## Bodybuilder's Bulletin

Bulletin No. 101

### TGM 6x4 Tipper overhang

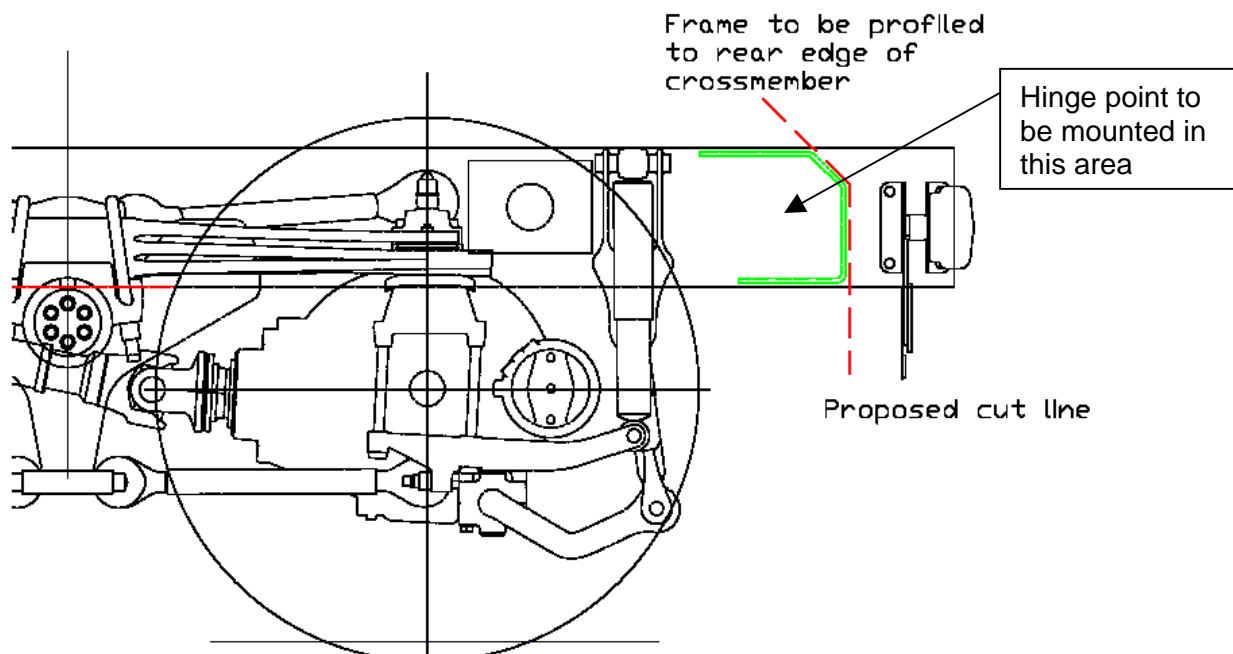
However, the frame side members protrude beyond the final crossmember and these must be cut off flush (or near flush) with the rear face of the final member.

It is **not allowed** to install a hinge-pin in the area of chassis frame beyond the final crossmember.
